ADDENDUM NUMBER TWO

Date: September 10, 2013
 To: Mr. Brian Kugler
 University of North Carolina Charlotte
 From: Charles E. Cardwell, PE, LEED AP
 Re: Cone Plaza Repairs
 University of North Carolina Charlotte
 SCO ID: 12-09714-01A
 SKA Project: 120345.2

P1

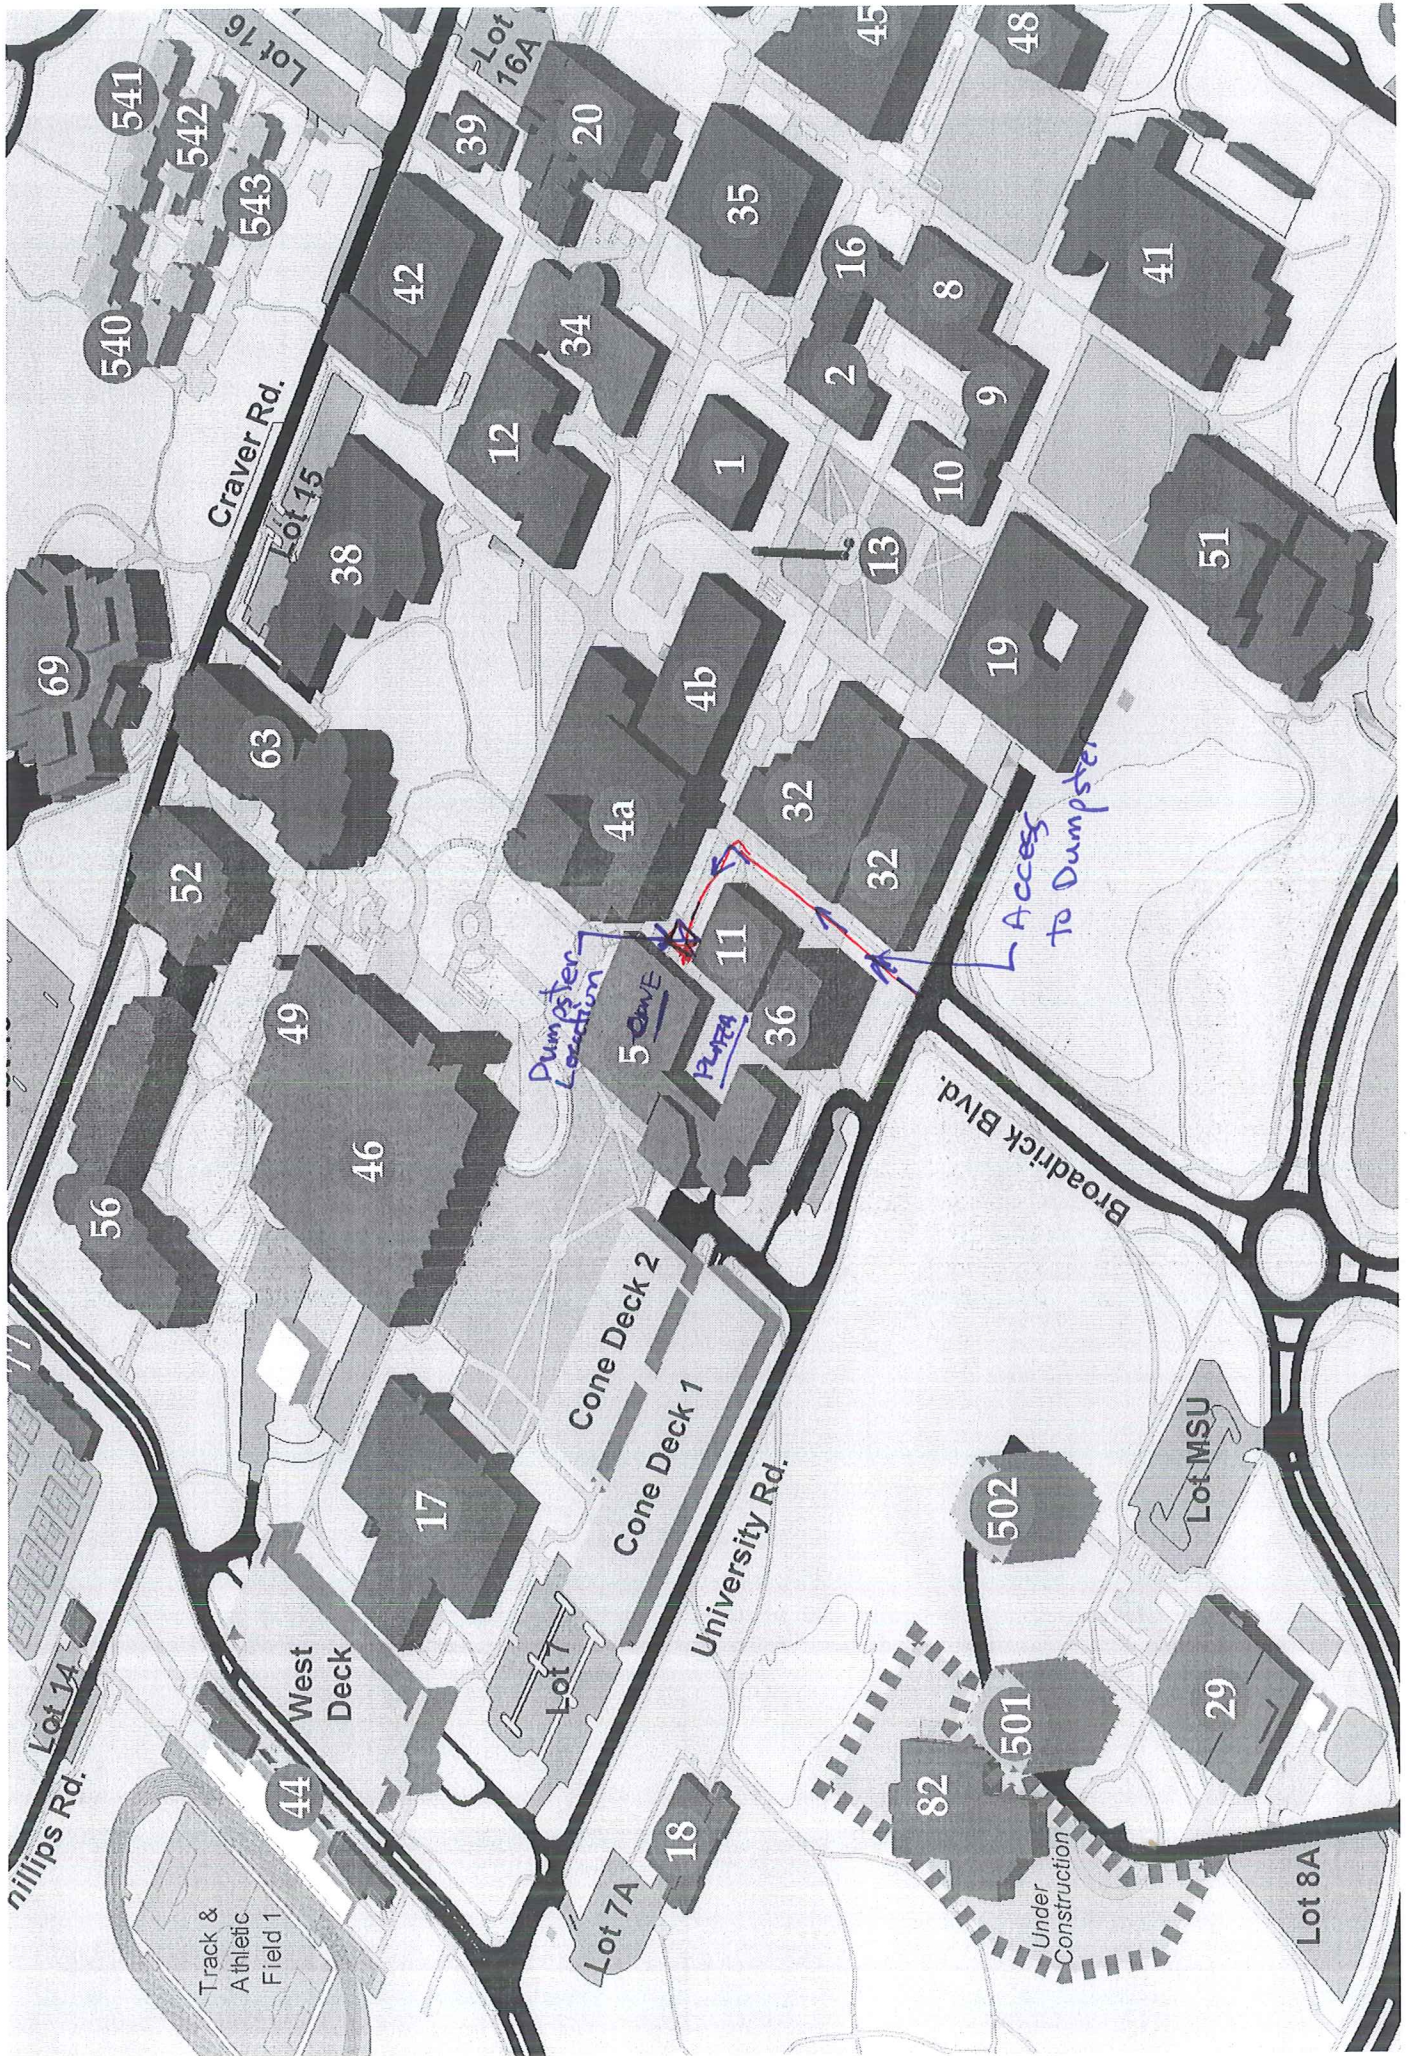
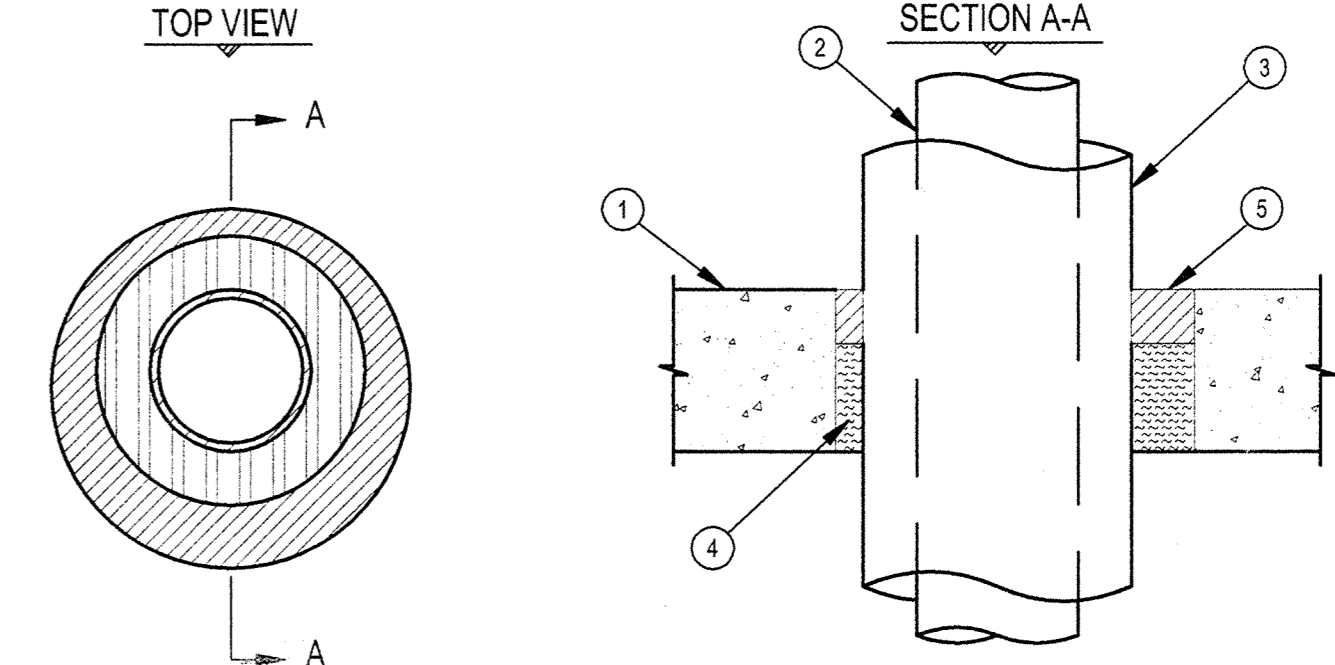
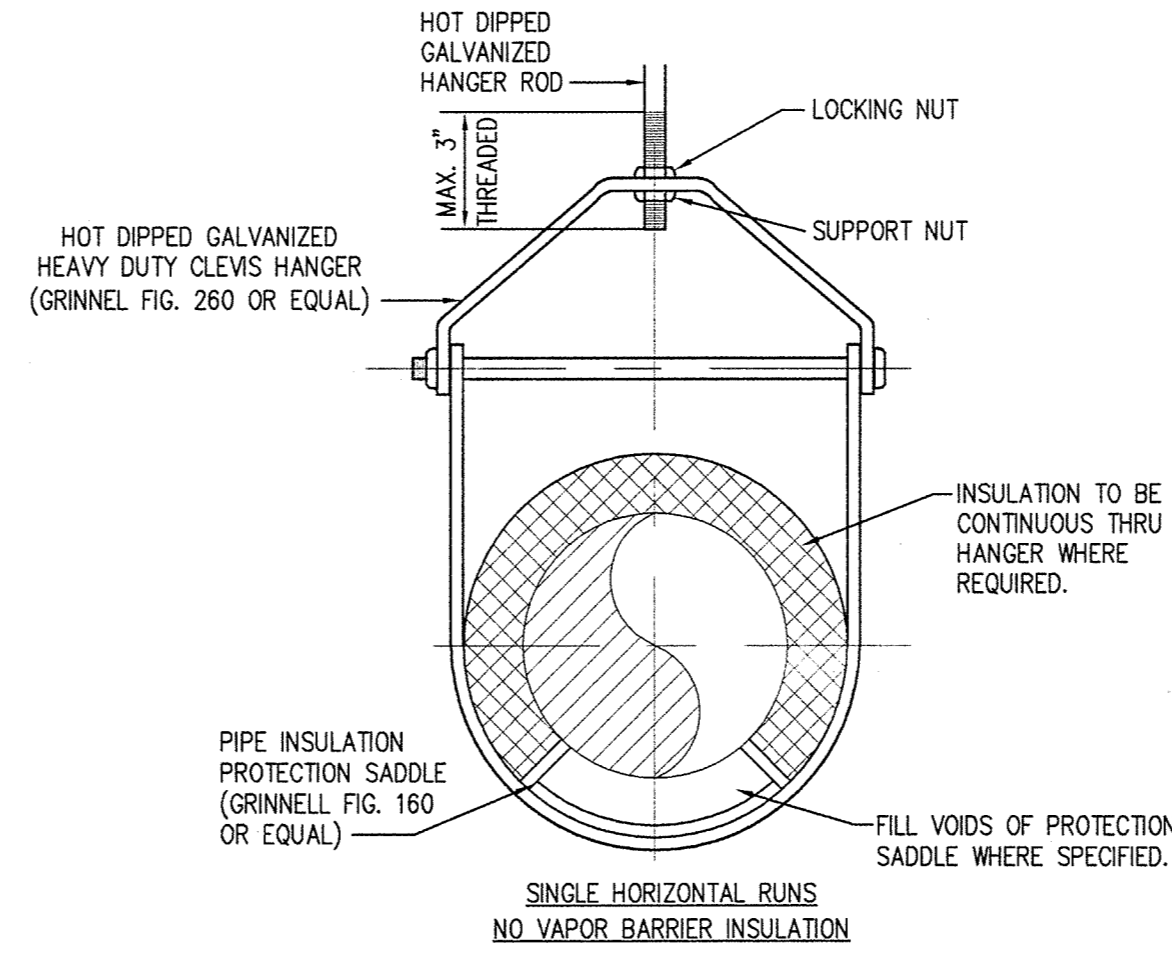
1. Drawing Sheet P1 is attached and issued as a complete replacement to the original drawing.
